Subject: LaSalle County Station Units 1 and 2
Design Assessment Report (DAR)
High Frequency Load Assessment
NRC Docket Nos. 50-373/374

The purpose of this letter is to document proposed changes to the LaSalle County DAR, Appendix H, which were discussed in a telephone conference with Mr. A. Bournia on July 30, 1981. The proposed changes will be incorporated into a future amendment to the DAR.

FIGURE 4-4-39

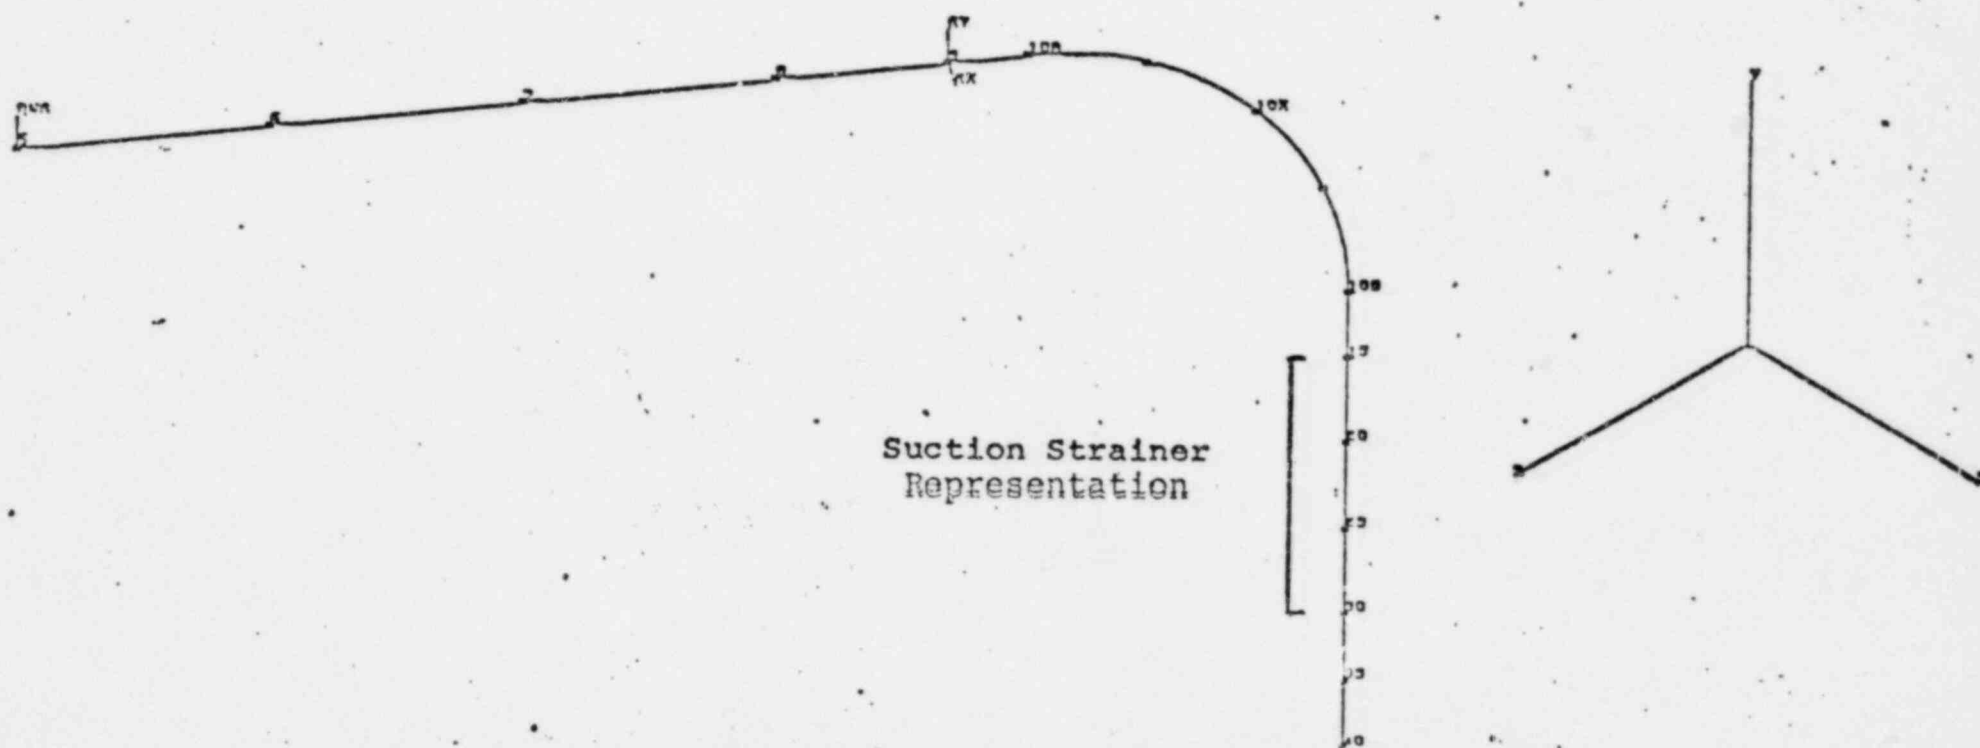
Tables H.4-21 & 22 compare the restraint reaction and node point stresses, respectively, for subsystem RH-42. For this subsystem chugging and CO do influence the bounding loads (RH-42 is not loaded by PSF). As the tables illustrate both the restraint reactions and node point stresses decrease as a result of utilizing the 4TCO spectra.

FIGURE H.4-40

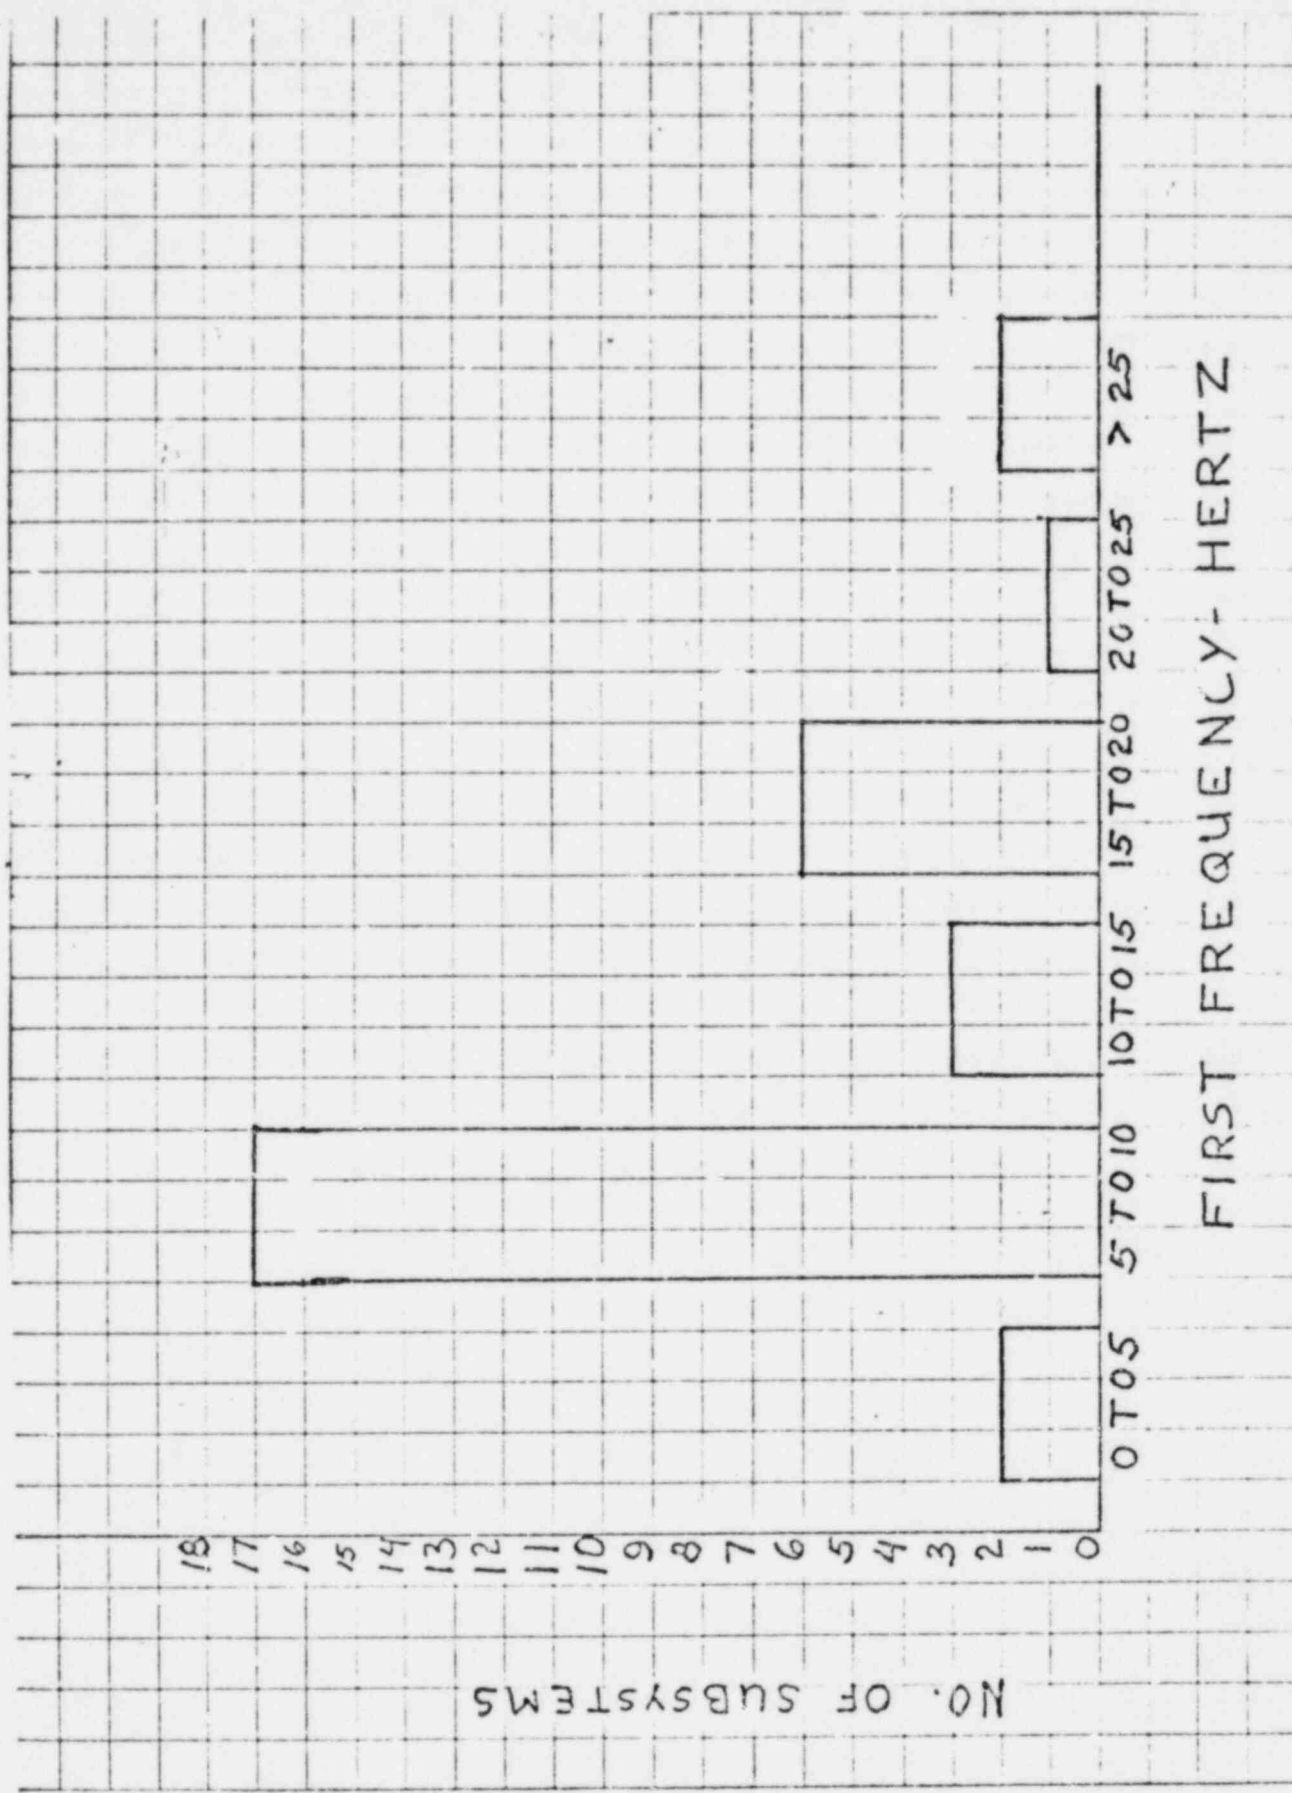
A survey of the fundamental frequencies was made of all subsystems penetrating the containment wall below elevation 730'. The distribution of these subsystem is shown in Fig H.4-40. The two high frequency subsystems found are part of the RHR safety relief discharge piping as shown in Fig. H.4-41. They are almost identically routed, consist of approximately 8 feet of 2 inch schedule 80 piping, and have no supports.

FIGURE H.4-41

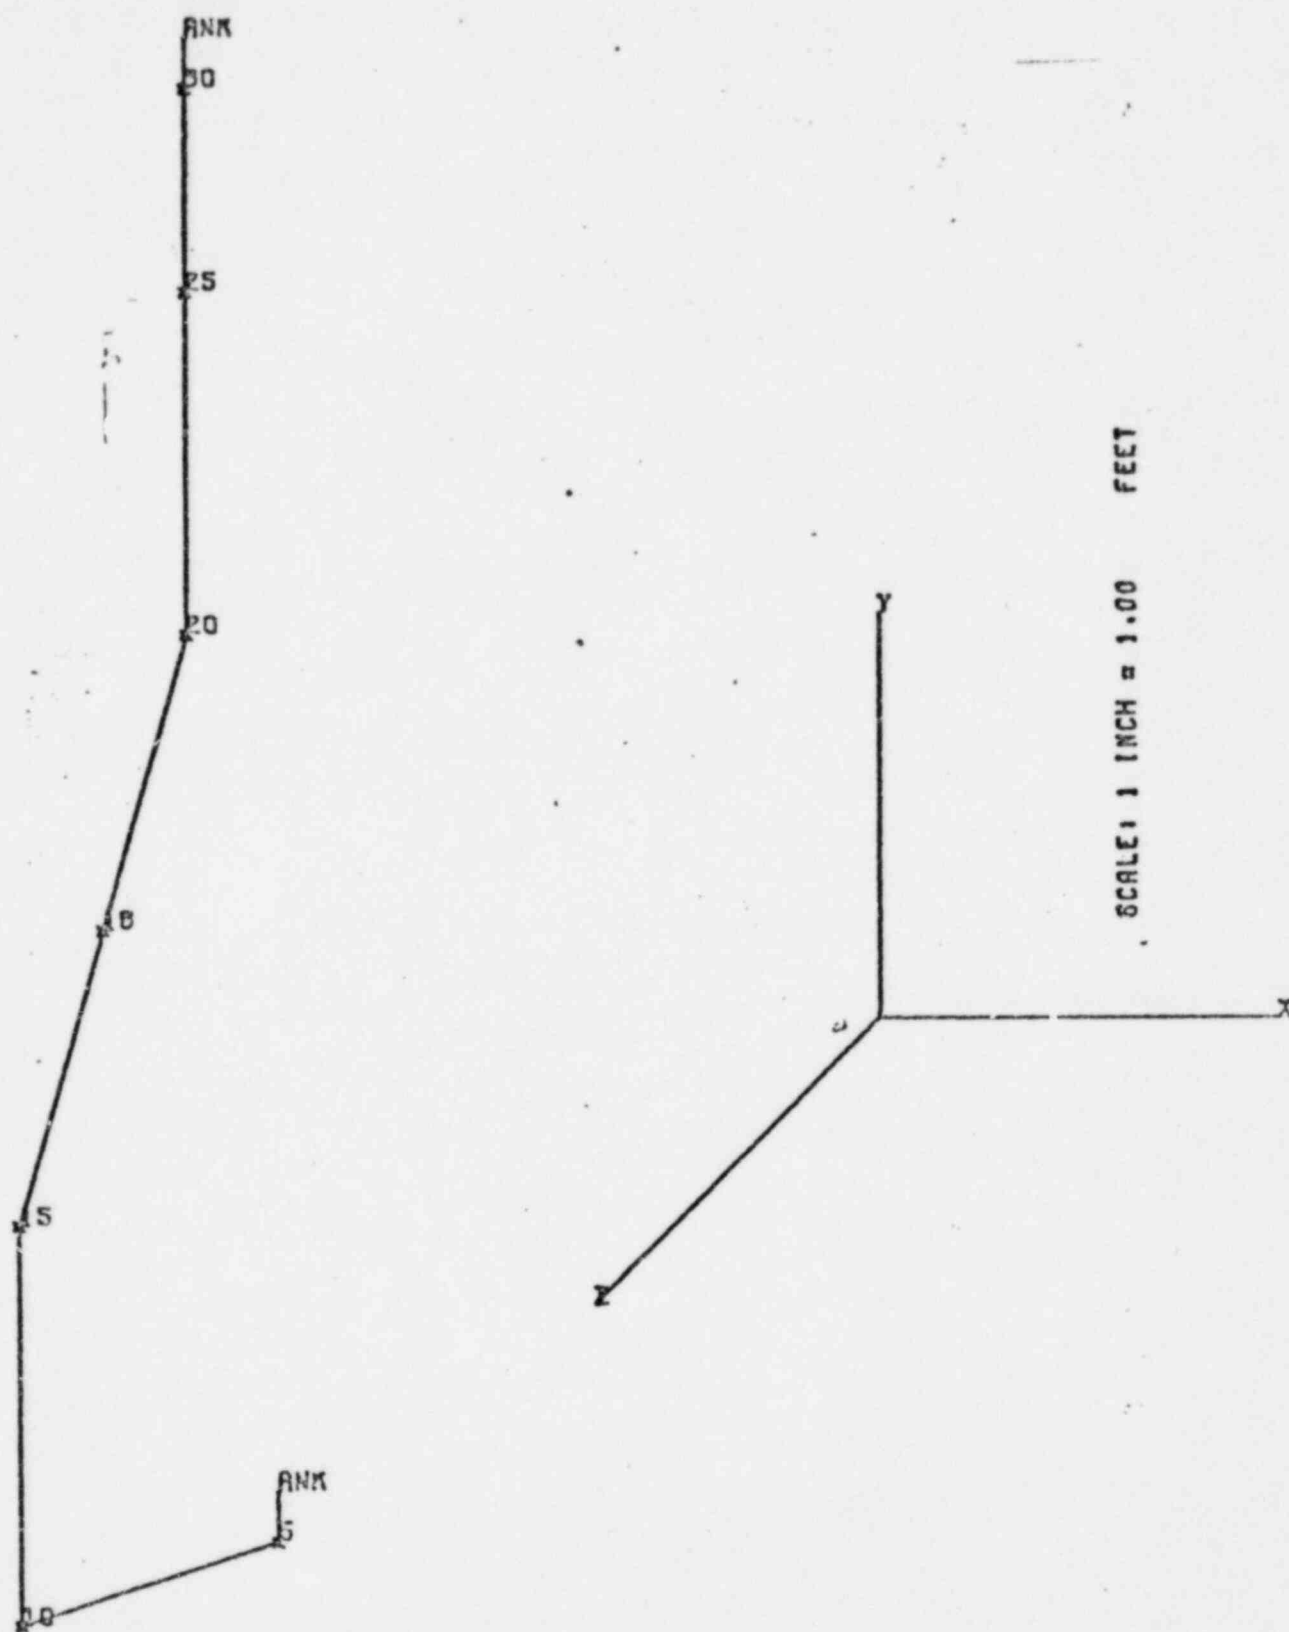
The highest ratios of calculated stress to allowable stress of equation 9 are shown in Table H.4-22, 23. These stresses must be increased 9 times in order to exceed the Code allowables.

Considering the ^a ~~low stress~~ ^{stress} levels in these subsystems, that material certifications are available to increase the allowable stresses, and that using a time history analysis will reduce the impact of the high 4TCO response spectra, the current stress analyses of these subsystem are sufficient to show their adequacy to withstand the increased 4TCO loads at the 698' elevation.
